Re: "Marshall & Moore Apartments"
1973/1977 Marshall Avenue lots (Revised SPR File # 17-206385)

Marshall & Moore Apartments Project Exceeds the Maximum Height Permitted in RM2 Zoning

Marshall & Moore Apartments Project Requires Major Variance to Encroach in the Interior Side Yard Setbacks for Off-Street Parking Facility

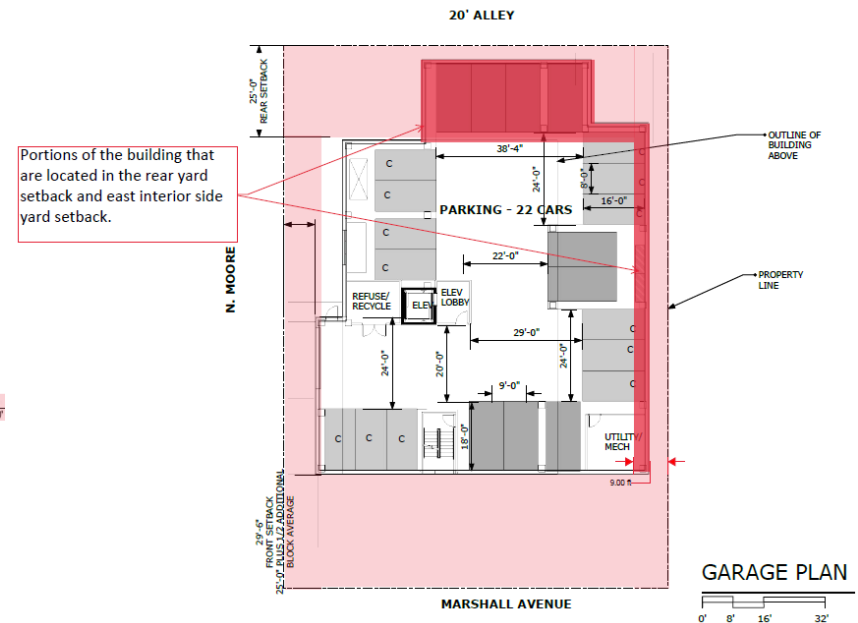
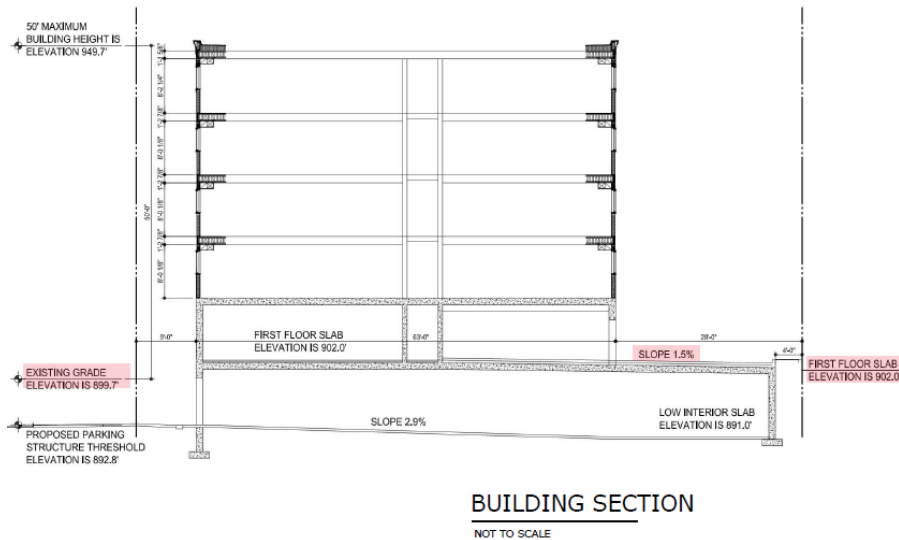
The proposed above-ground parking facility, accessed from the public alley, is located 4' from the east interior side property line and requires a major variance to encroach into the east interior side setback, required to be 9' from the property line.

The Marshall & Moore Apartments Project Requires Major Variance to Increase the Maximum Lot Coverage

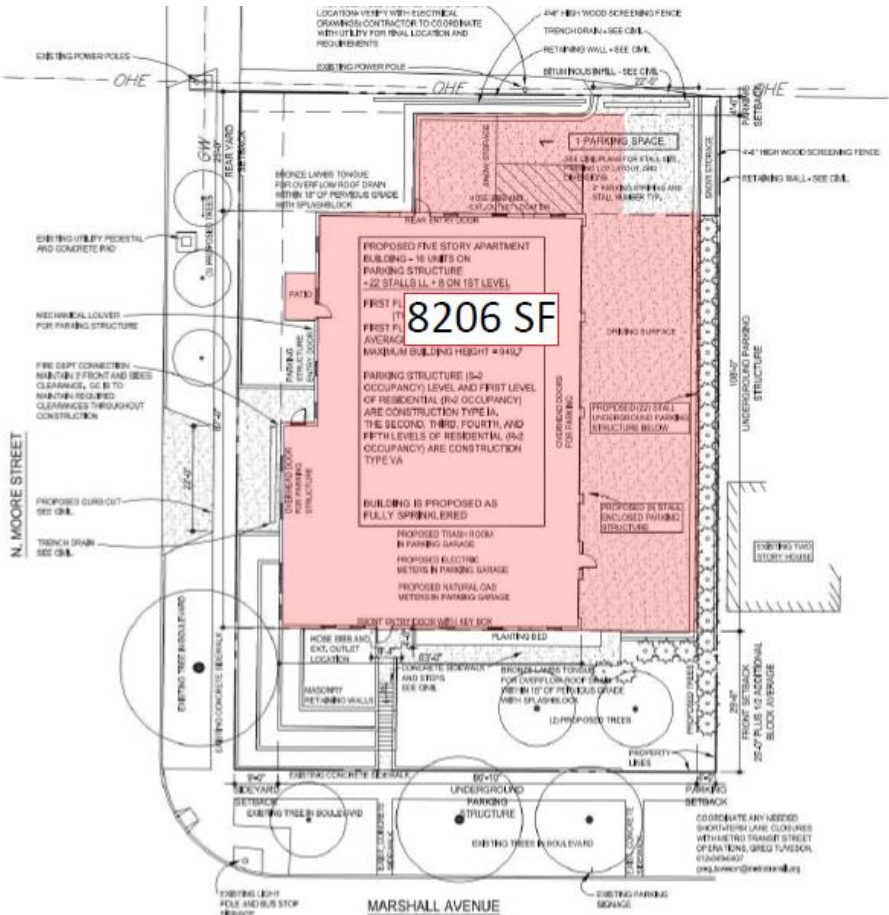
As previously demonstrated, the “underground” parking structure is 2.3’-1.94’ taller than established grade (see Exhibit C). Therefore, the entire footprint of the structure, including the “underground” parking structure, shall be included in the calculation for lot coverage.

8,206 SF / 15,169 SF = .541 OR 54.1% of the total site area

Marshall & Moore Apartments Project Does Not Meet Minimum Off-Street Parking Requirements

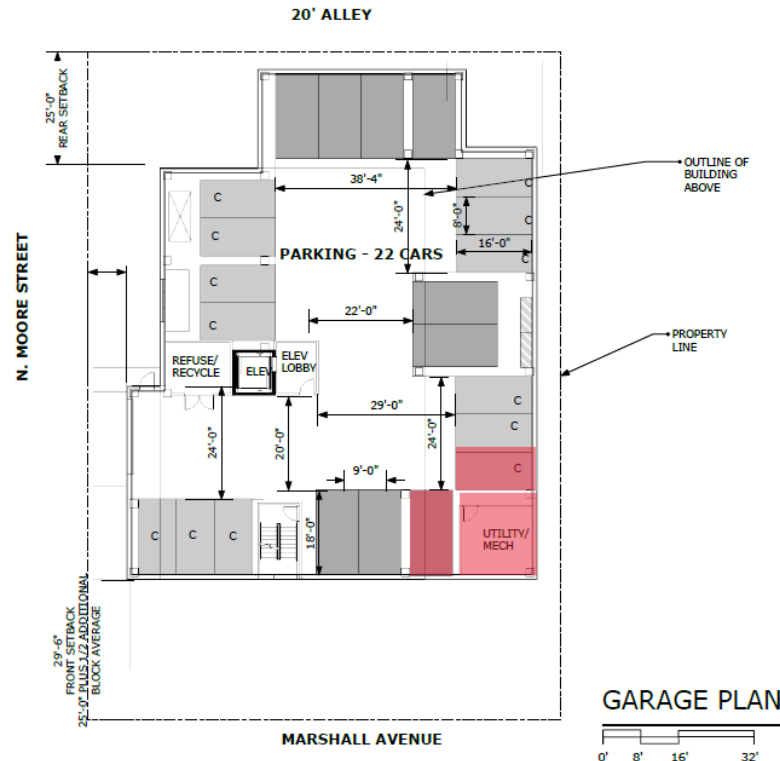
The proposed utility and mechanical room is located in the southeast corner of the “underground” parking structure. This room is flanked on both sides with parking spaces, rendering the room inaccessible. This will result in the loss of 1 parking stall to accommodate the required access to the utility and mechanical room.

Marshall & Moore Apartments Project Does Not Meet Minimum Off-Street Parking Requirements

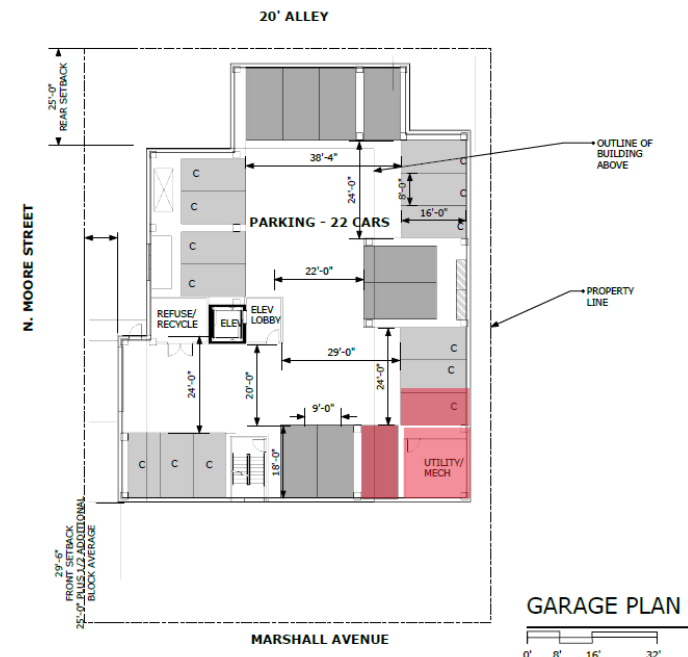
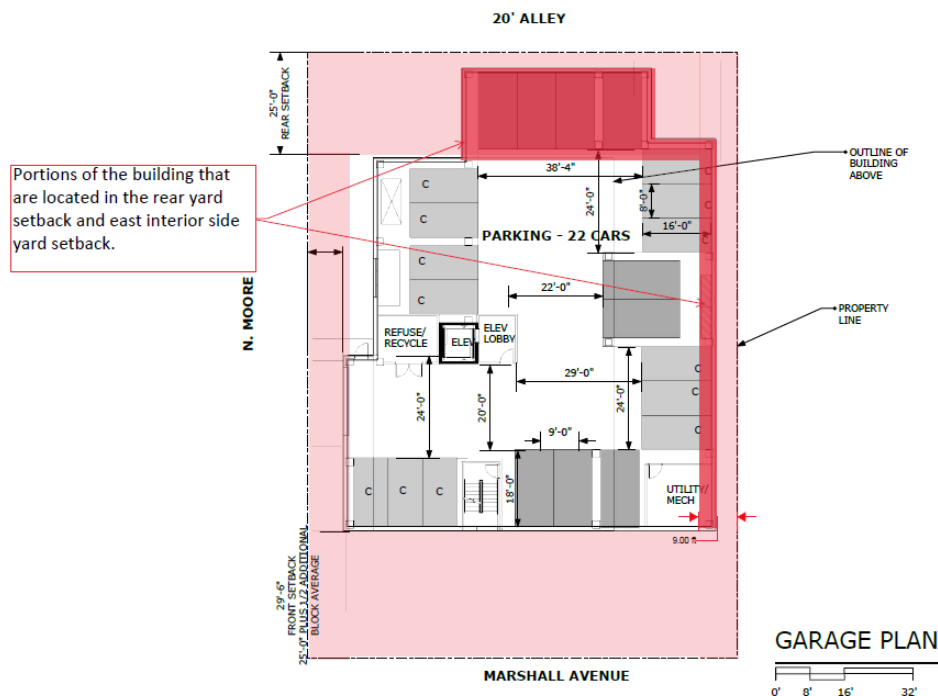
As previously demonstrated, the “underground” parking is above the established grade (see Exhibit C) and 10 stalls do not comply with building setbacks and the utility and mechanical room is inaccessible (see Exhibit E), which results in the loss of 1 more parking stall. Only 20 of the proposed 31 parking stalls would not require a major variance, as shown in the Project application. A minimum of 30 parking stalls are required for 13 – 4-bedroom units and 3 – 3-bedroom units. The Project requires a variance to reduce the minimum off-street parking from 30 spaces to 20 spaces.

FIGURE LU-K. GENERALIZED 2030 LAND USES, SOUTHWEST SECTOR

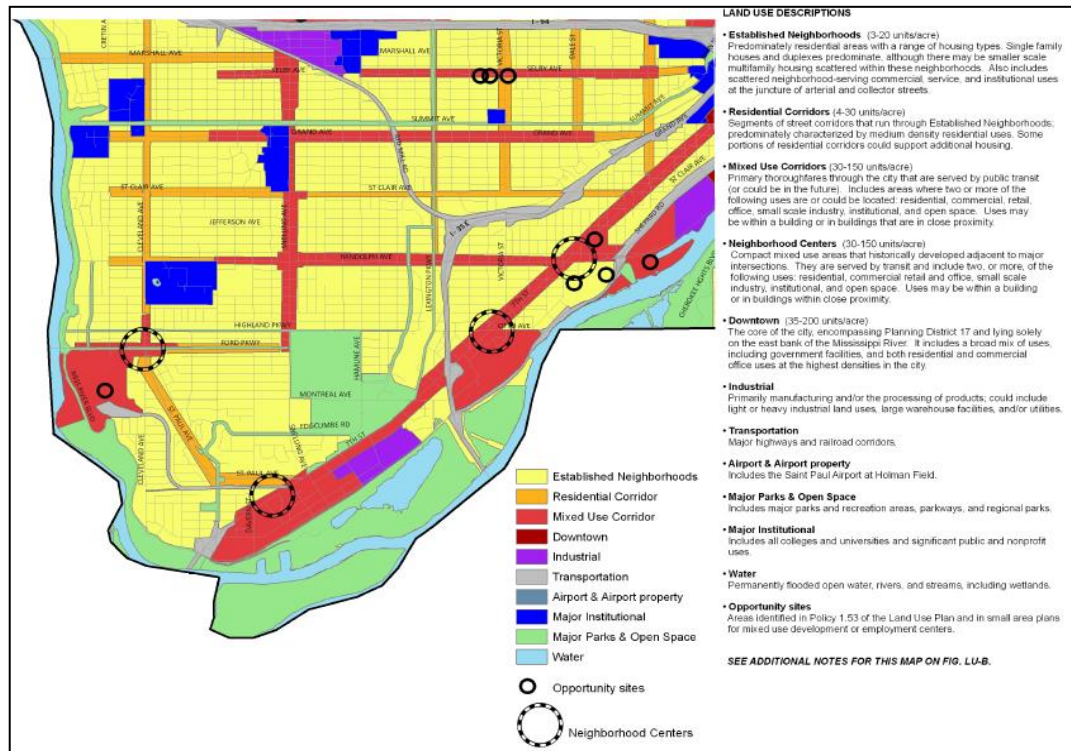
At 49 units per acre, Marshall & Moore Apartments density exceeds the St. Paul's *Generalized 2030 Future Land Use Comprehensive Plan*. Marshall Avenue is a designated Residential Corridor in the St. Paul's *Generalized 2030 Future Land Use Comprehensive Plan*. The guided density range for Residential Corridors is 4-30 dwelling units per acre and expressly stated in Strategy 1.1 and the Land Use Table.

9. *Sufficient landscaping, fences, walls and parking necessary to meet the above objectives.*

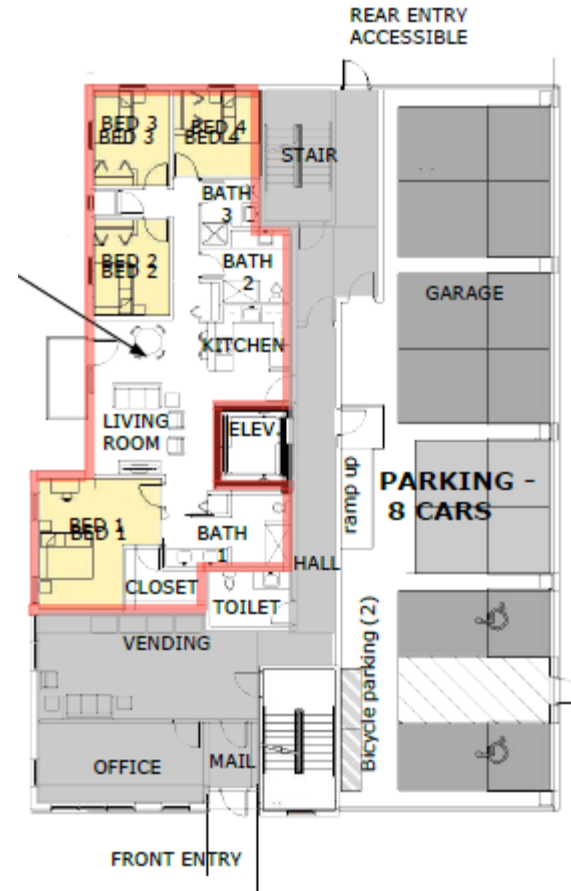
- There is insufficient landscaping proposed to mitigate stormwater runoff to the east.
- The proposed landscape buffer is insufficient to provide a reasonable screen to adjacent properties from the proposed on-site parking area and driveways.
- See Exhibit E for parking analysis. Parking is insufficient as proposed by the applicant without approval of major variances.
